# CROSSROADS AT MEADOWBROOK-MIXED USE PRELIMINARY PLAN

PCD FILE NO: SP-20-011

# preliminary plan V\_3 planning redlines.pdf Markup Summary 7-22-2021

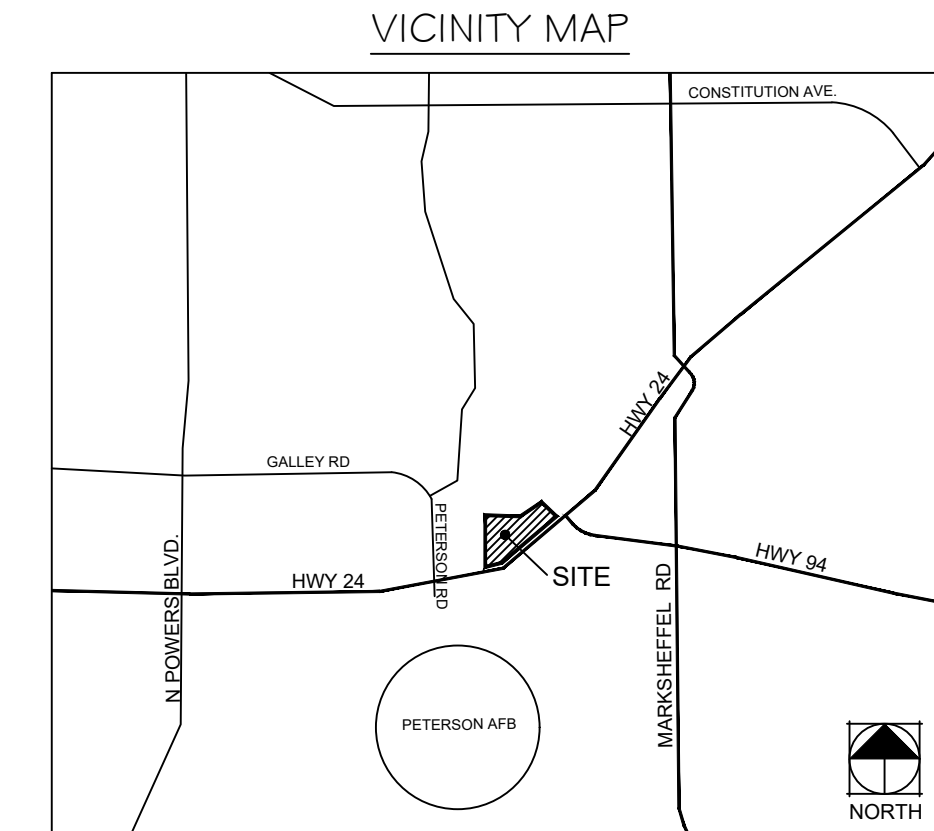
This is a odd note?  
Delete this note  
please; (The CDS  
associated with the

Plat will specifically  
define the curb,  
pavement, and Ped  
ramps....) site dev  
plans are internal to  
the lot for the most  
part.

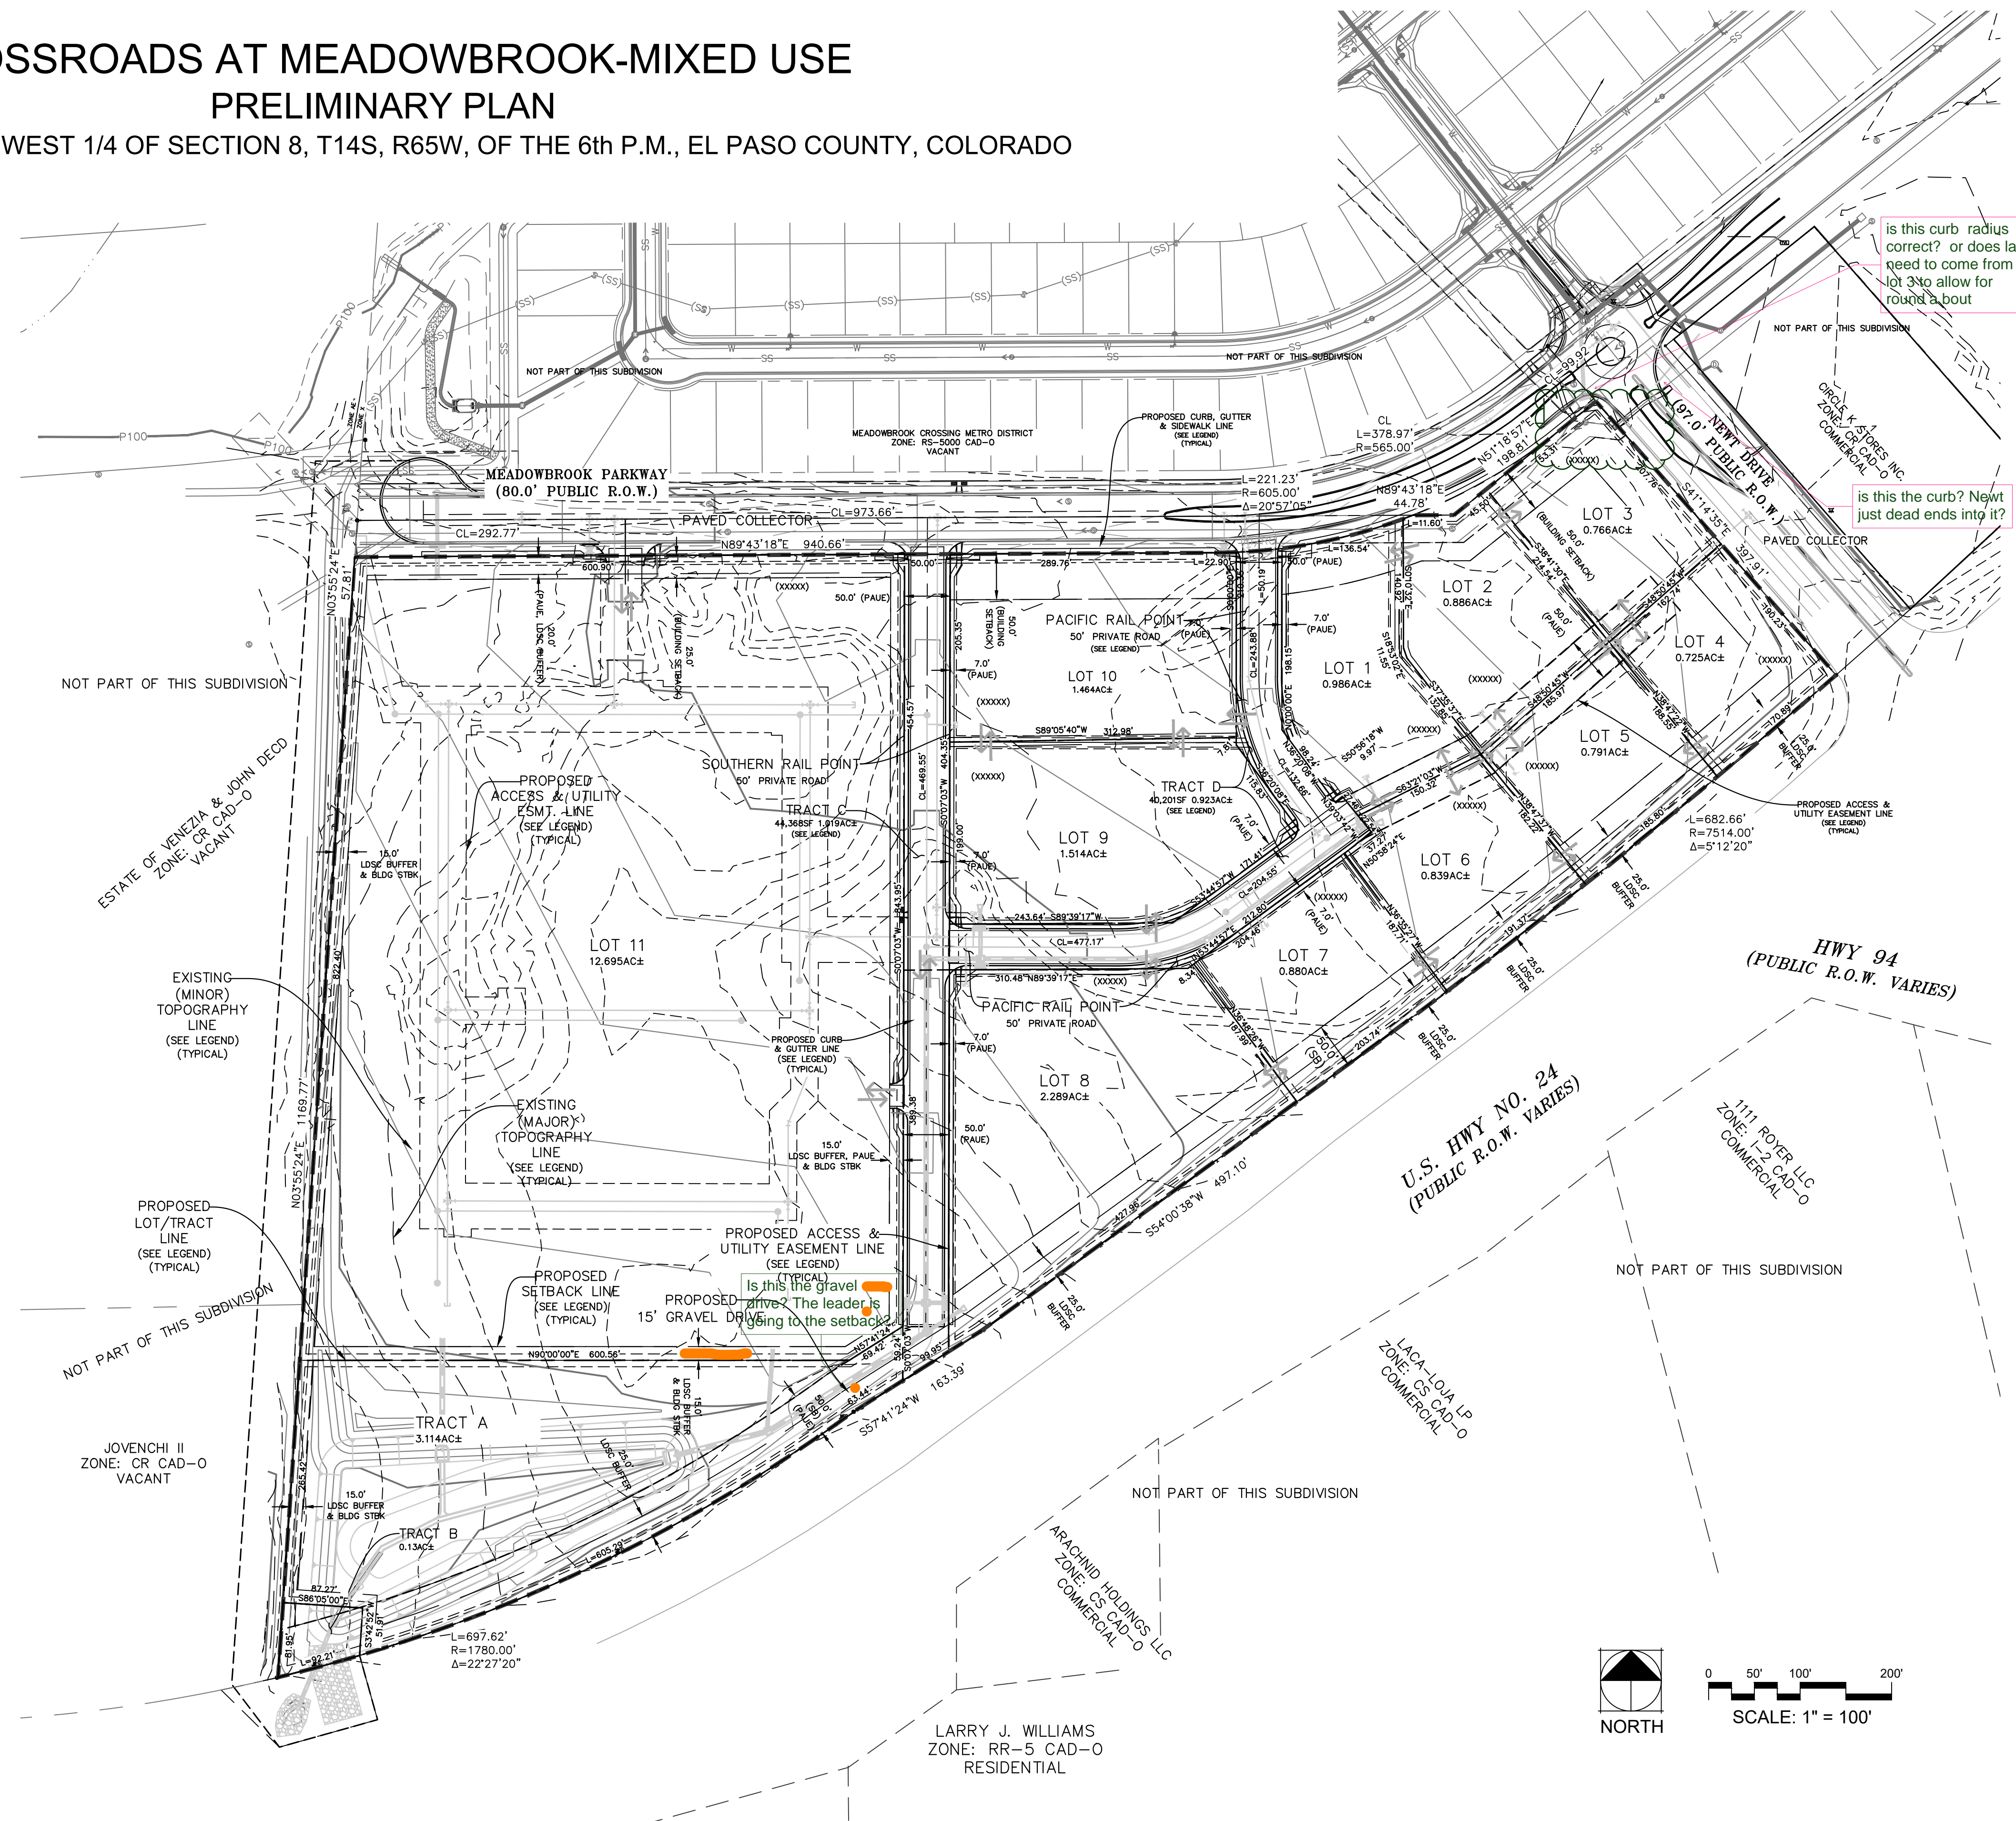
Is this the gravel drive? The leader is going to the setback?

is this the curb? Newt just dead ends into it?

is this curb radius correct? or does land need to come from lot 3 to allow for round a bout
